**FINAL DRAINAGE REPORT FOR
HIGH VIEW ESTATES
6665 WALKER ROAD
COLORADO SPRINGS, COLORADO 80908**

March, 2022
Revised May, 2022

PCD File No. MS-222

HIGH VIEW ESTATES
6665 WALKER ROAD
PROPOSED DRAINAGE PLAN

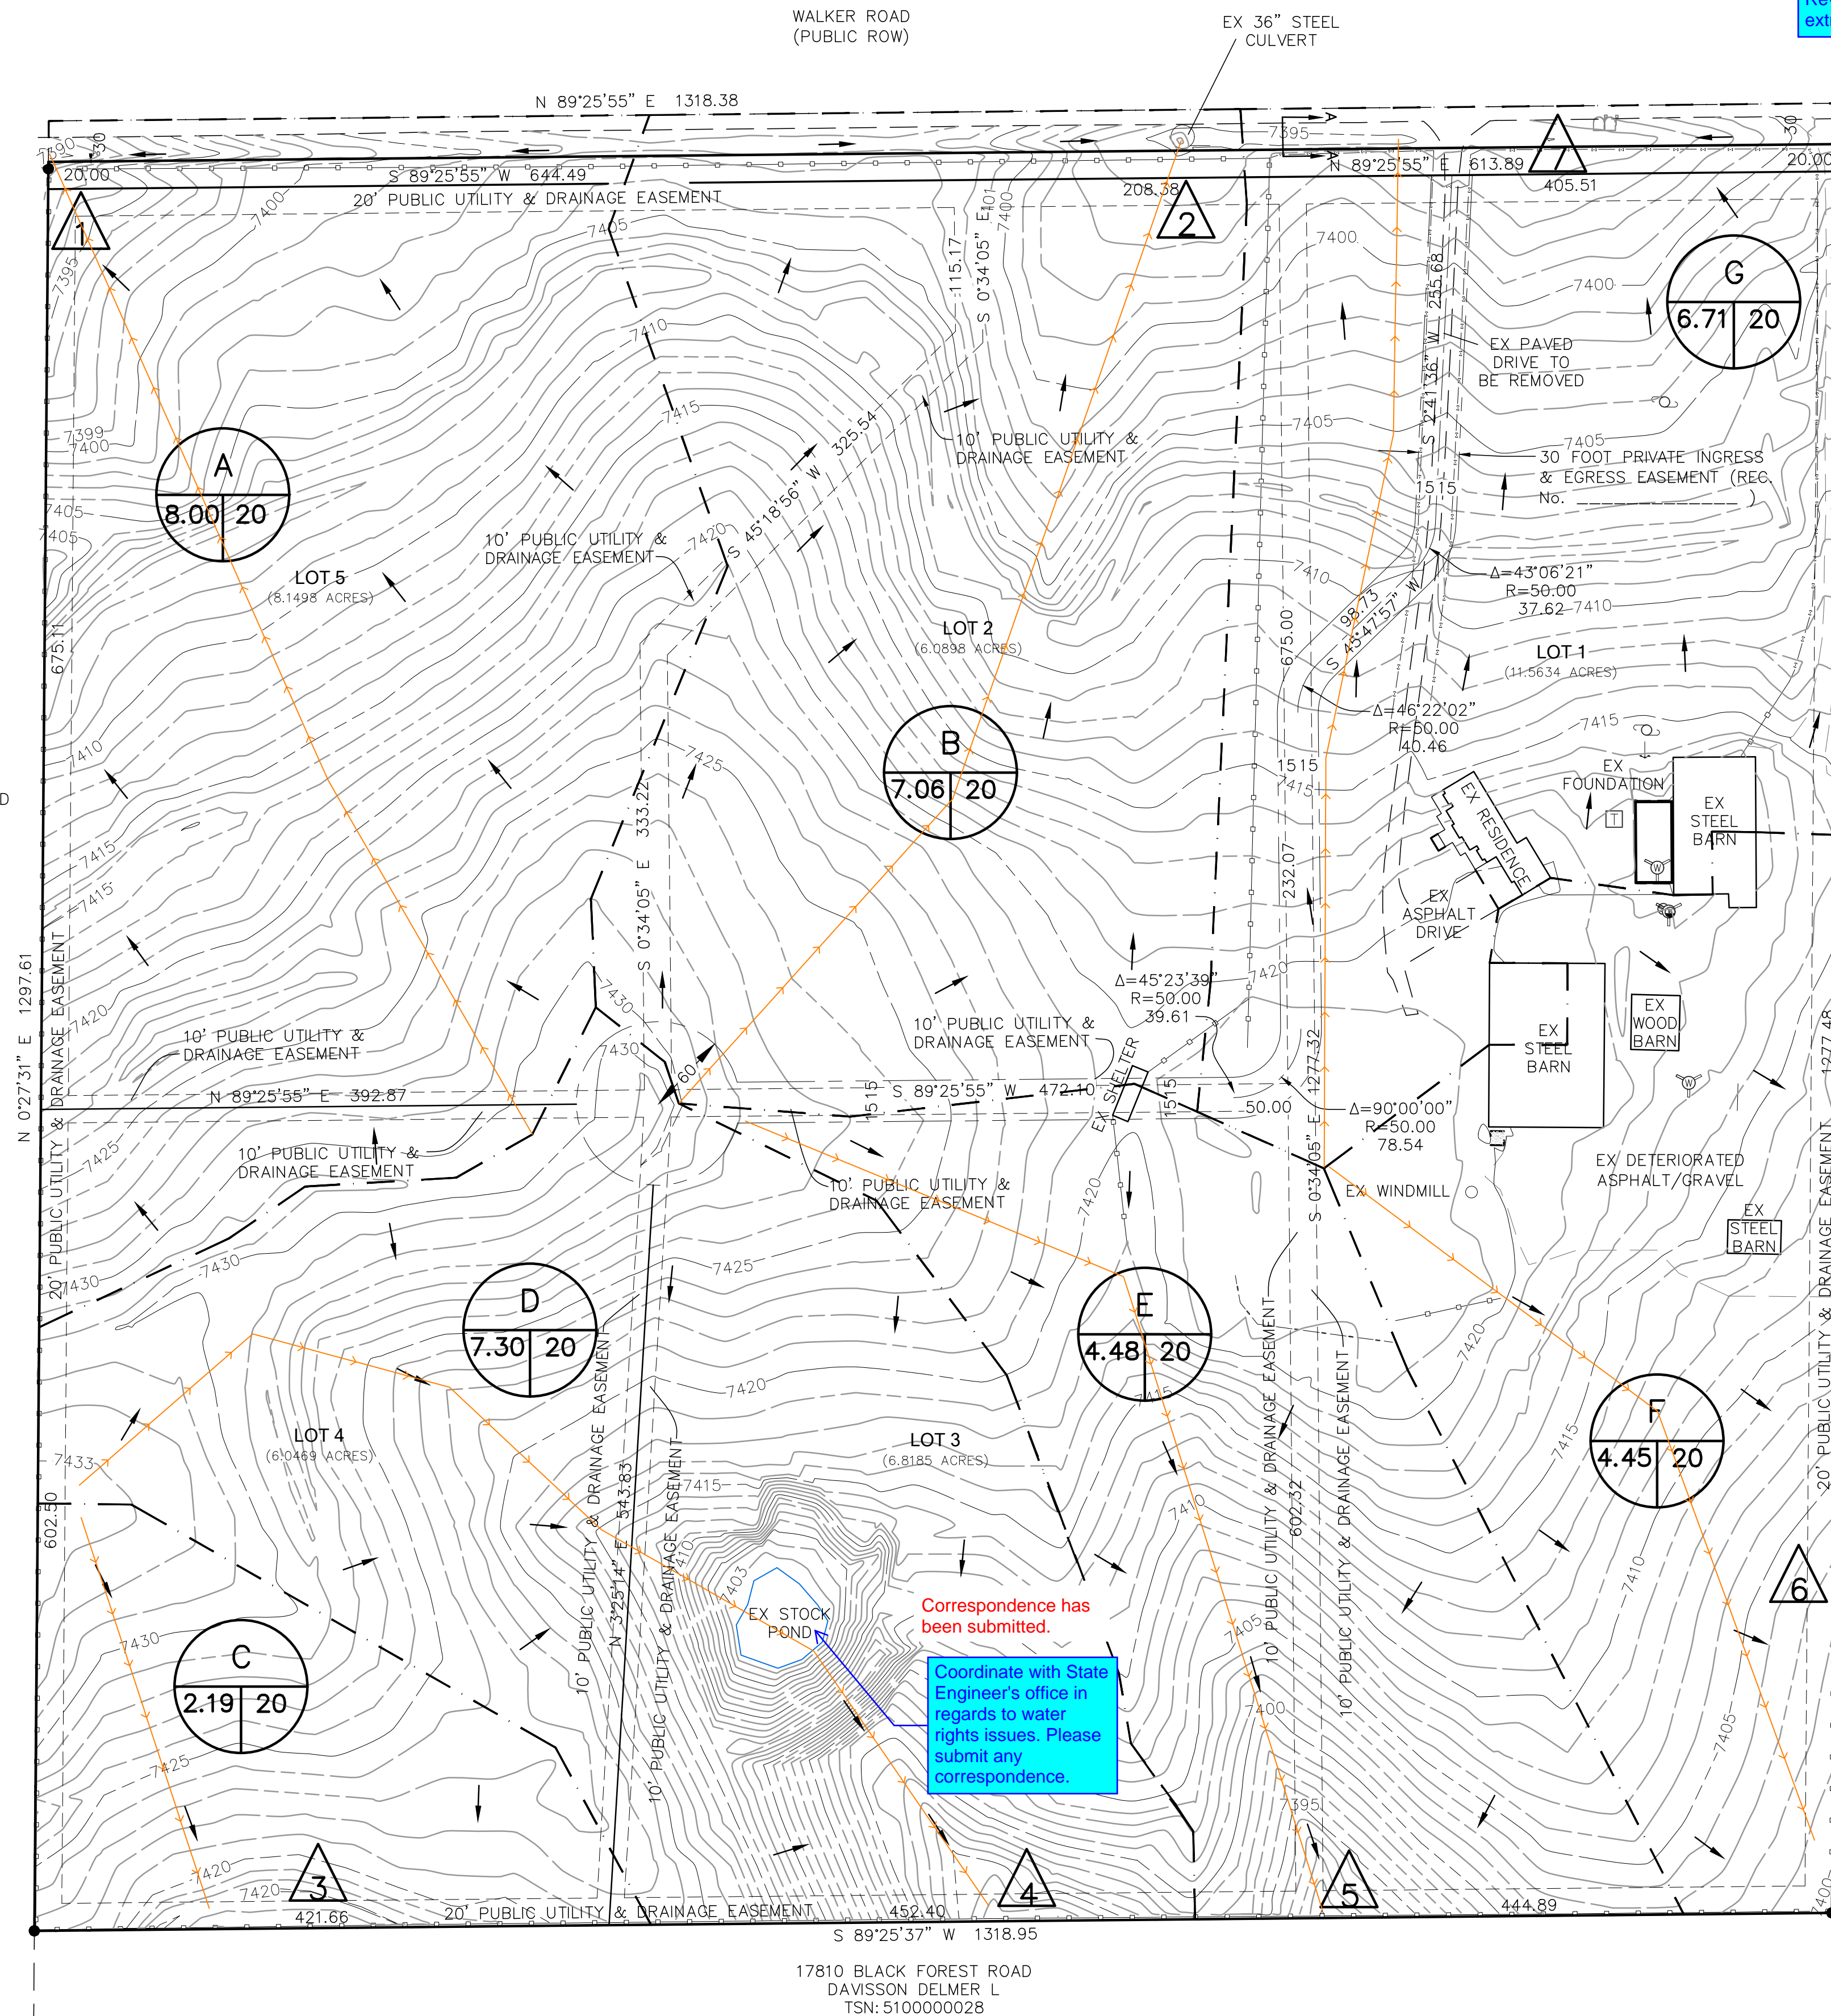
Revise tables once different C values are used per Daniel's comment on pdf pg 6 above.

Revised.

EX SWALE CROSS SECTION A-A
N.T.S.

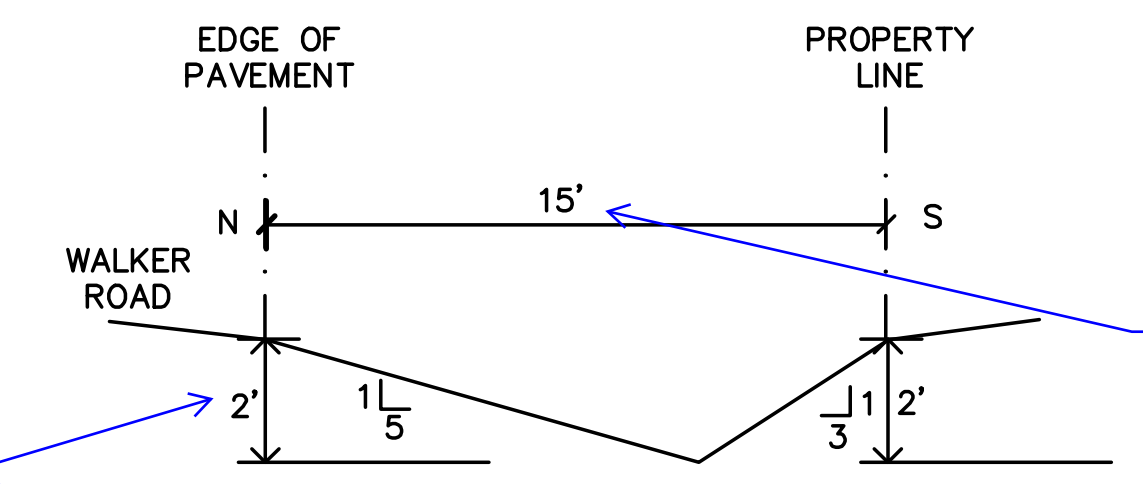
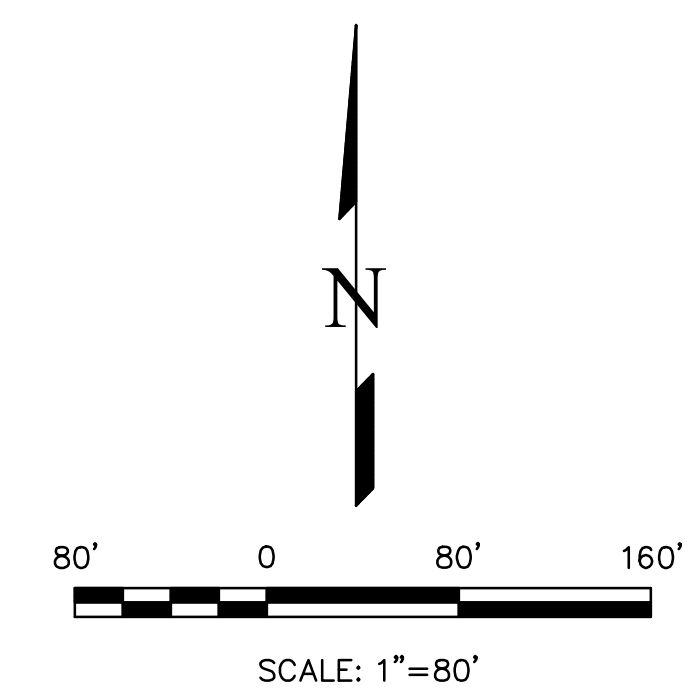
Per the open channel flow calculation it appears 2 feet is the runoff depth. Per ECM 3.3.4.B.2.0.5' of freeboard is required. Revise to include that extra depth.

Per swale calculation it appears the top of the stream is 16" so this swale is undersized. Revise to allow for that width.

Revised.

Revised to be more accurate with a 17' top width and 1' bottom width.
